Upper Trishuli-1 HEP (216MW)

DOOSAN NEPAL BRANCH OFFICE	Address & Contact No. : Four Square Building, Naxal, Kathmandu, Nepal (P.O Box : 1387) + 977 1 692 3014	Project No. H20002	DOCUMENT DISPATCHED BY Courier Service ☐ Messenger ☐ Post-Air Freight ☐ Document System or E-mail ■ By hand ■
DOCUMENT DISTRIBUTION	■ POWER CHINA (Subcontractor) ☐ Doosan's Site Office		
SUBJECT	Submission of Review Note RN-0132, RN-0133 and RN-0134

REVIEW NOTE

Contractor	**Doosan Enerbility**		
Title of the Document	Excavation and Initial Support Drawings of Main Access Tunnel to Powerhouse		
Document No.	UT1-C-090-CVL-DG-64002	Revision	0B
Date of Documents	20.05.2022	Received Date	31.05.2022
Transmittal Form No.	UT1-HEP-DHI-D-0247		
Previous Review Date/Status	N/A	Prev. Review Note No.	N/A
Review Note No.	**RN-0132**	**Present Review Date**	**05.06.2022**
		Present Review Status	**AN**

Drawing No.: UT1-C-090-CVL-DG-64002 (sh. 1/6), version 0B

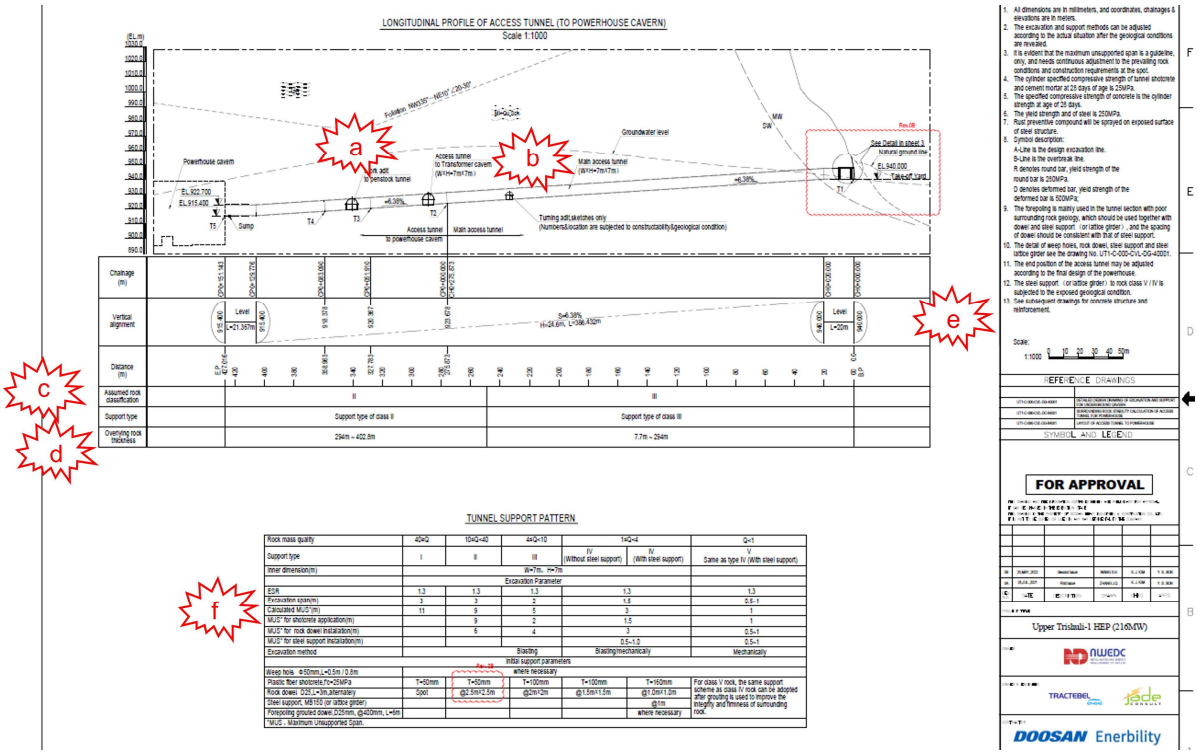
(a) Incorporate in the drawing the geological findings from the detailed investigation of discontinuities around the Powerhouse Complex. Provide one overall hemispherical plot and a small table with discontinuity details (Dip and Dip Direction, only).

(b) Turning bays not required. Tunnel is large enough for parallel/simultaneous mucking and muck loading.

(c) Delete Support Type row.

(d) Provide overburden thickness for the given chainages above.

(e) Item 13: Make clear reference to respective layout drawing and concrete drawing.

Drawing No.: UT1-C-090-CVL-DG-64002 (sh. 2/6), version 0B

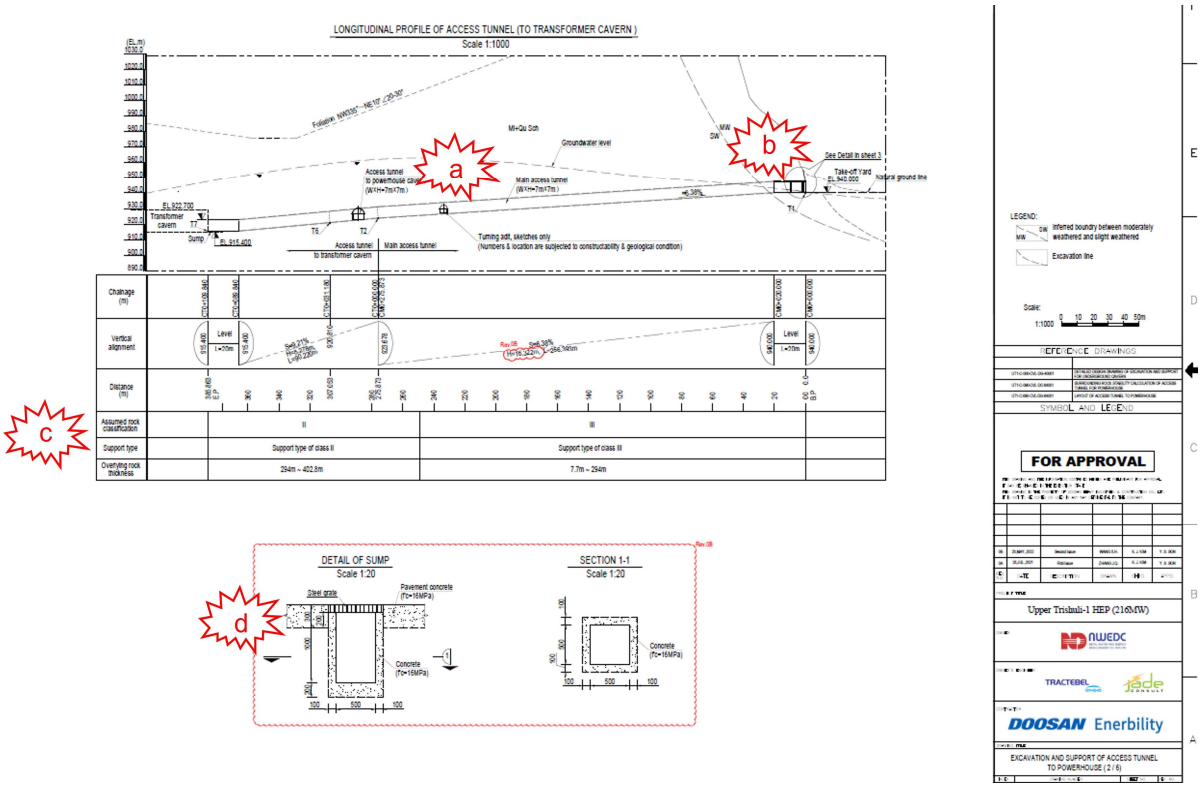
(a) Turning bays not required. Tunnel is large enough for parallel/simultaneous mucking and muck loading.

(b) Adjust slope topography to actual conditions.

(c) Delete Support Type row and provide overburden thickness for the given chainages above.

(d) Reconsider sumps sizes and locations. Indicate clearly the location of sumps. Consider actual requirements (= discharge into tunnel in rainy season). Consider also constructability.

Drawing No.: UT1-C-090-CVL-DG-64002 (sh. 3/6), version 0B

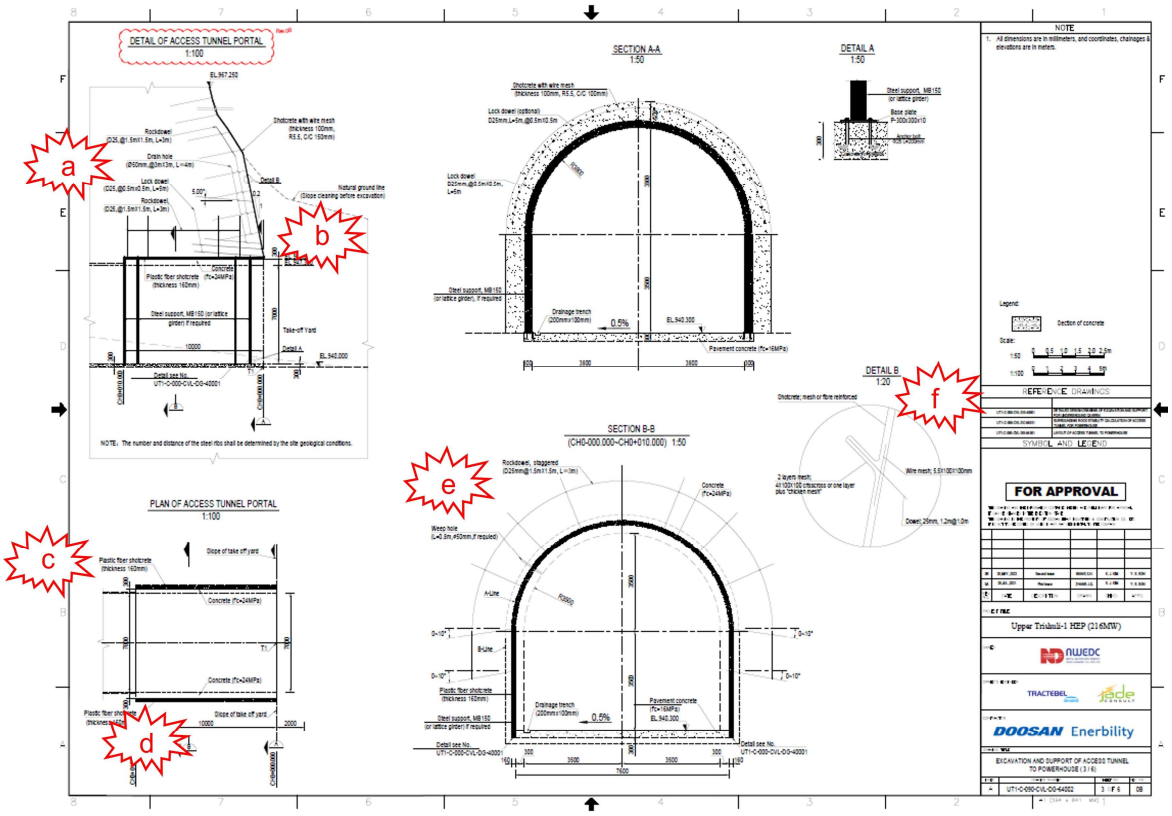
(a) Adjust slope geometry to as actual built conditions and indicate slope support accordingly.
(b) Adjust portal support to actual as built conditions. Indicate permanent concrete portal structure.
(c) Provide actual as built support for roof support.
(d) Provide longitudinal slope of concrete invert.
(e) Adjust roof and sidewall support to actual as built conditions.
(f) Adjust drainage ditch to actual as built conditions.

Drawing No.: UT1-C-090-CVL-DG-64002 (sh. 4/6), version 0B

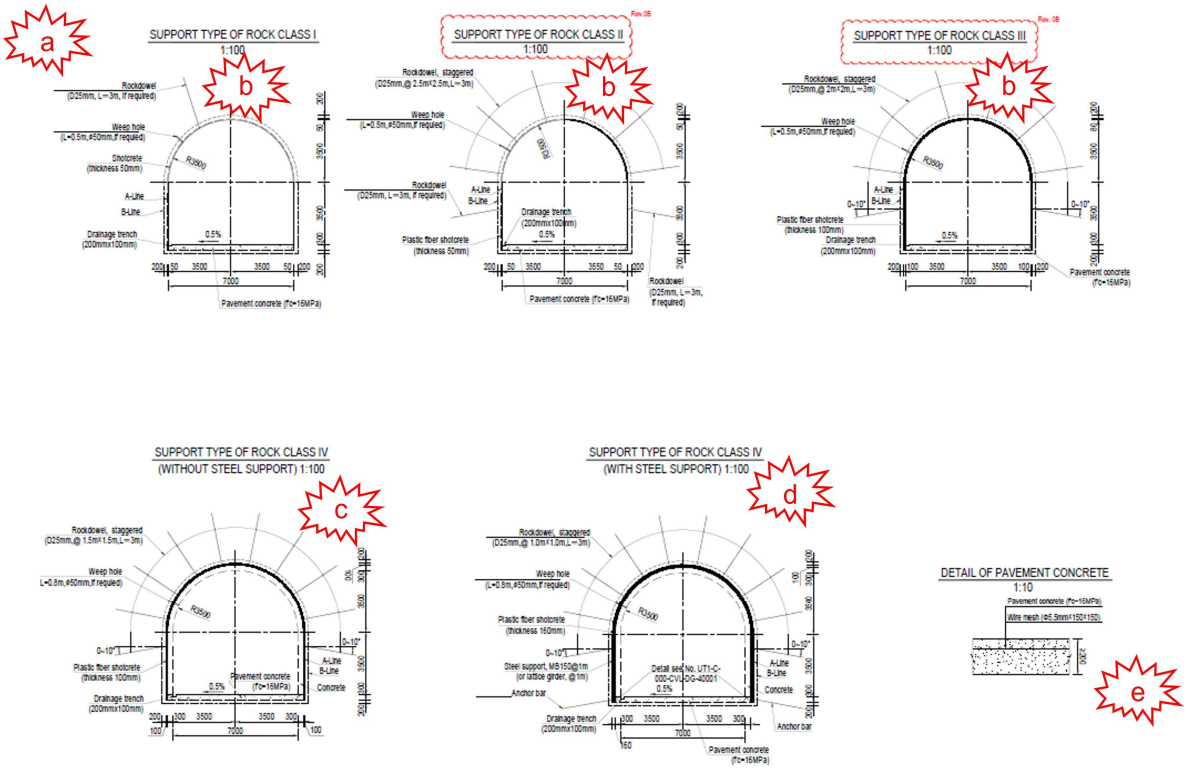
(a) Subdivide drawing for Class I, II, III and Class IV, V.

(b) Indicate roof bolts and pattern. Provide drawing of bolts or refer to respective approved drawing. **50 mm of shotcrete in Class II rock are certainly insufficient, particularly when considering that dowels in sidewalls are optional. 80 mm thick shotcrete over the whole perimeter is appropriate.**

(c) Indicate alternatively to concrete liner, shotcrete inner liner with respective strength and thickness.

(d) Same as (c).

(e) Reconsider reinforcement in concrete invert ref strength requirements.

Drawing No.: UT1-C-090-CVL-DG-64002 (sh. 5/6), version 0B

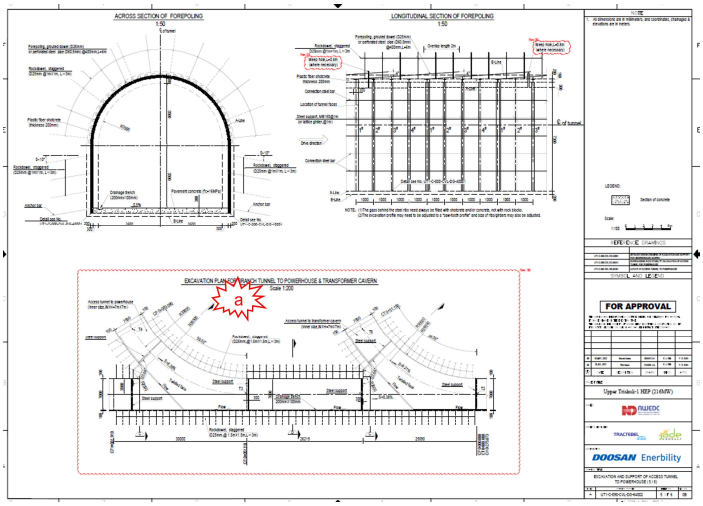
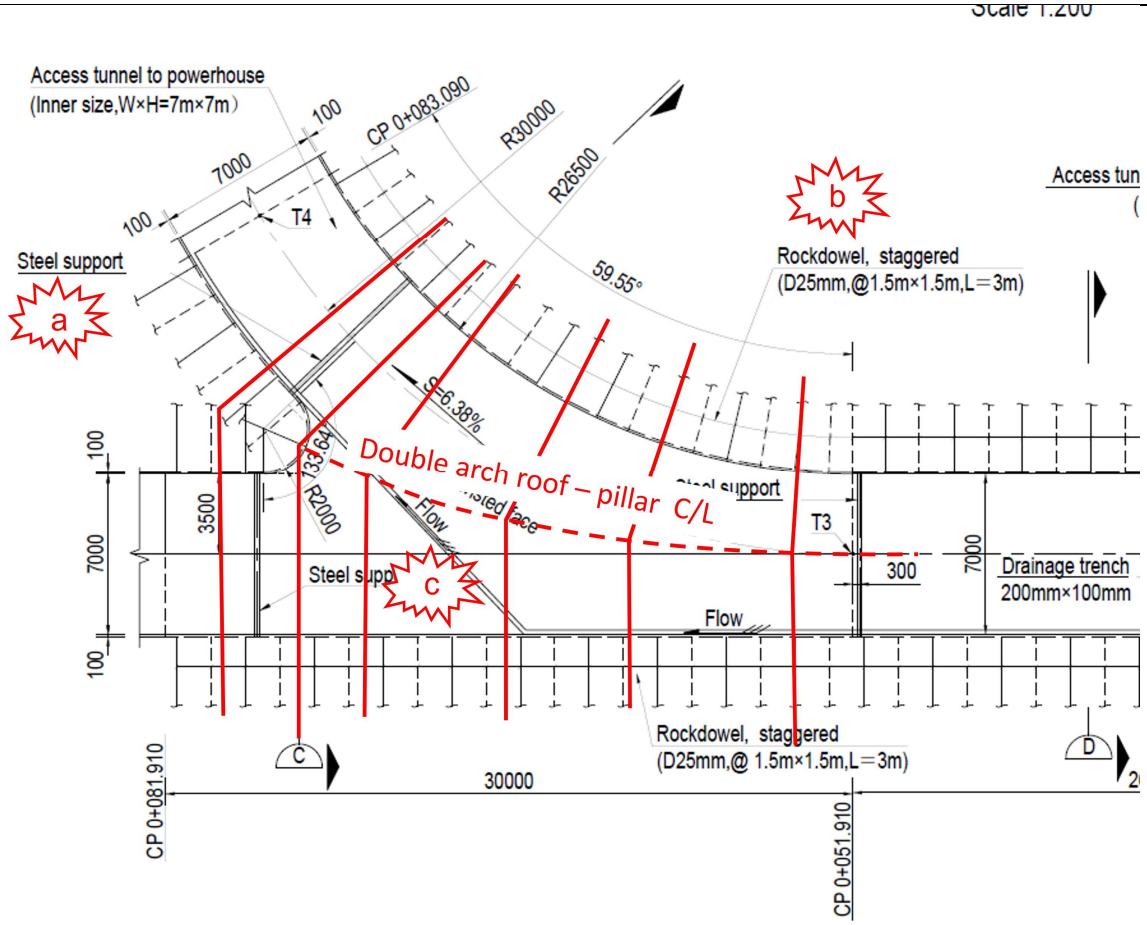
(a) See details below.

(a) Indicate steel support (ribs) as “as required”.

(b) Indicate support for Class III. The branches will presumably be opened in Class II rock. Q-values doubles as Joint Number J_n doubles in junctions. Therefore, use Class III support. Put in notes that it is assumed that the rock class is expected to be Class II, otherwise support needs to be adjusted.

(c) Provide a set of sections, cross sections similar as indicated above with Class III support, and a section along the “double arch roof-pillar centreline”, also with Class III support. Indicate additional support for the pillar in respective sections.

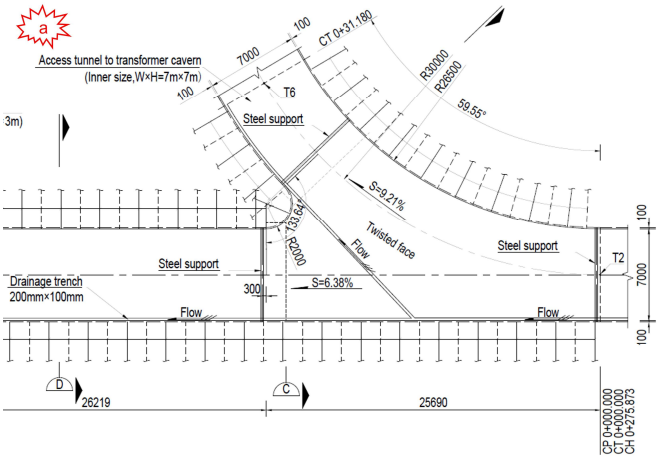
(a) Modify drawing for branch to Transformer Hall as shown above for the branch to Powerhouse.

Drawing No.: UT1-C-090-CVL-DG-64002 (sh. 6/6), version 0B

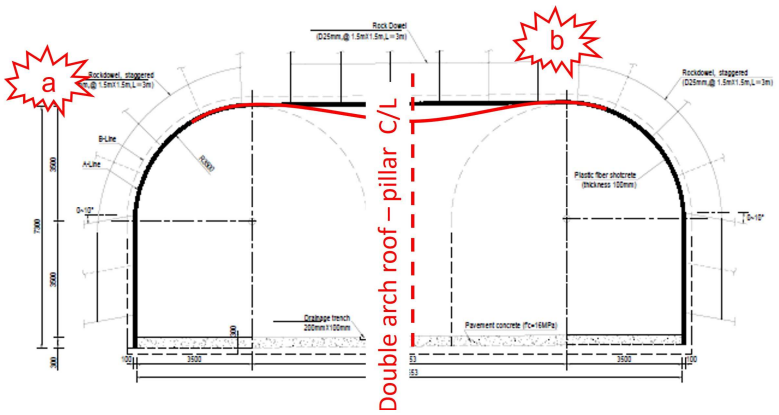
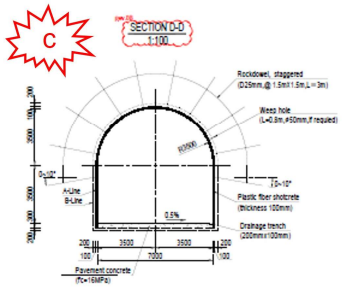
(a) Adjust to correct section geometry.
(b) Adjust to Class III support.
(c) Delete typical tunnel section, as this already given for the individual support classes.
(d) Delete safety instruction. Provide those in the Method Statement.
